Project: WBS 33604.3.1 (B-4262)
Bridge #217 on SR 1520 over Tributary to Cathy's Creek
Rutherford County

To: Meeting Attendees
Subject: Revised MINUTES OF MEETING
Date Prepared: November 18, 2010
Prepared by: Jim Mondolfi

PURPOSE/DESCRIPTION:		Pre-Bid Meeting
DATE & TIME:		Wednesday, October 27, 2010 10:30 AM
LOCATION:		NCDOT Bridge Management Unit Large Conference Room Raleigh, North Carolina
ATTENDEES		
Name	Representing	Telephone Number
	See Meeting Roster	
Jim Mondolfi	Ko/Florence & Hutcheson, Inc.	919-851-6066

BRIDGE NO. 217
33604.1.1 (B-4262)

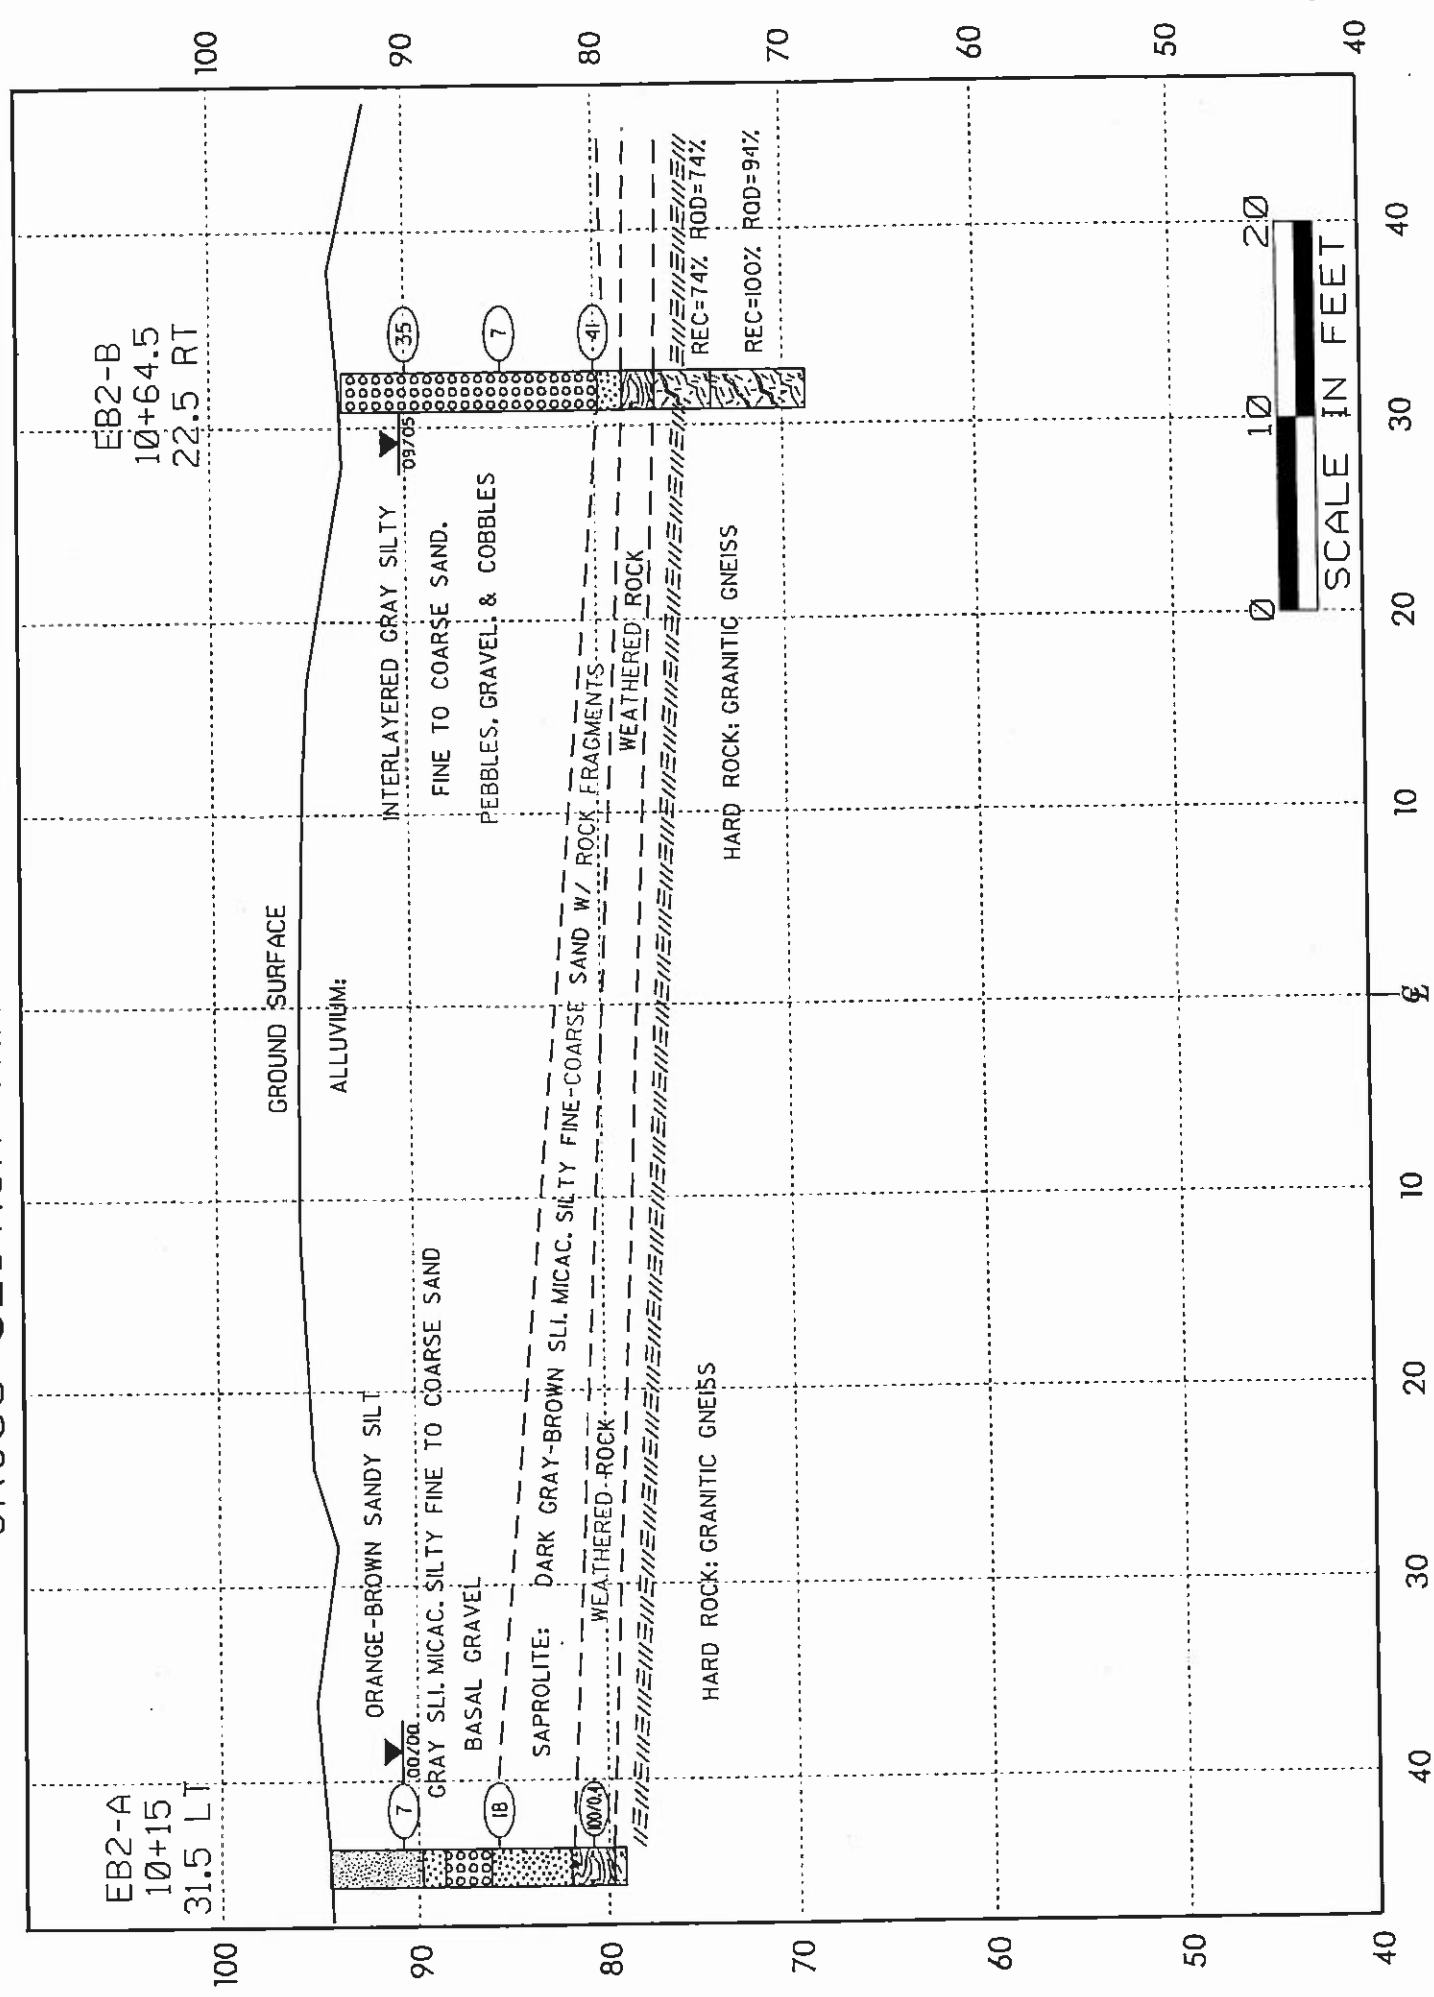
- 9) Boring logs and soil profile sheets are attached.
- 10) Item "Select Granular Backfill" is added to the contract. A revised bid sheet is attached.
- 11) The quantity for item "Filter Fabric for Drainage, Type 2" is increased from 710 SY to 1270 SY. A revised bid sheet is attached.

NC DOT BRIDGE 217 SR 1520
HEADWALL/JONGWALL DETAIL

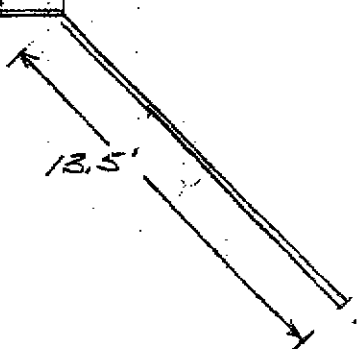
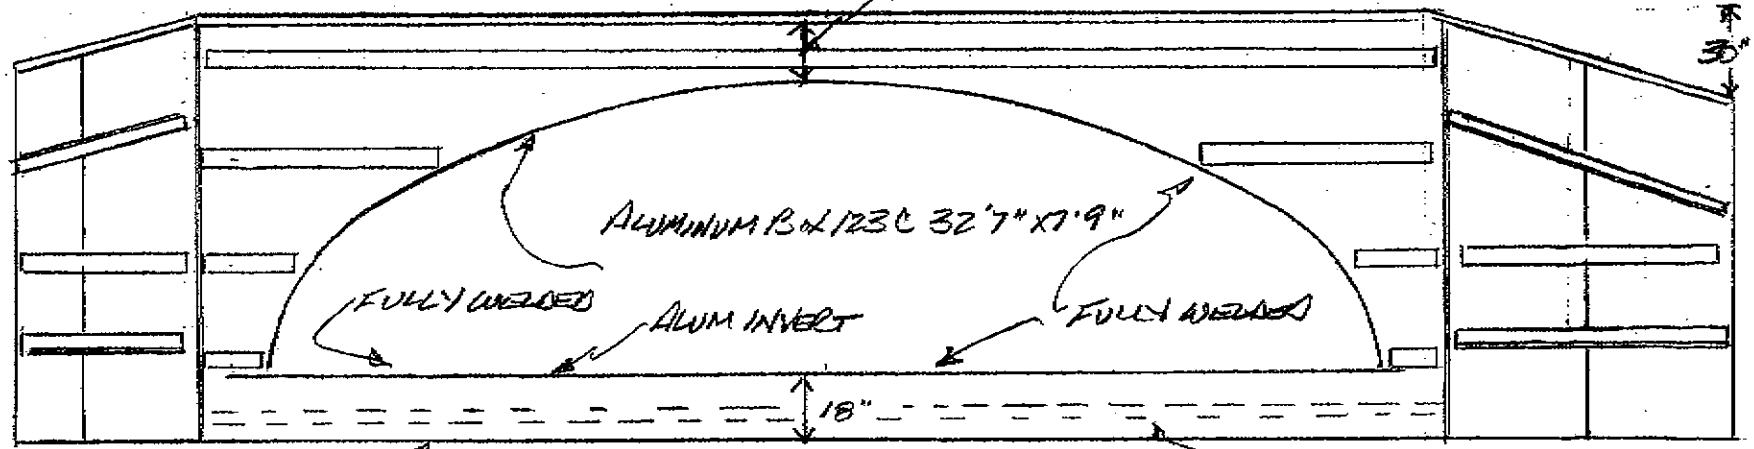
- 12) A sketch of the headwalls is attached for information only.
- 13) Backfill along the full length of the culvert with Select Granular Material for a width of four feet up to the height of the culvert. "Select Granular Material, Class 4 or Class 6" shall be used, or as per the recommendations of the manufacturer and as directed by the Engineer. Refer to Sections 265 and 300 of the Standard Specifications.
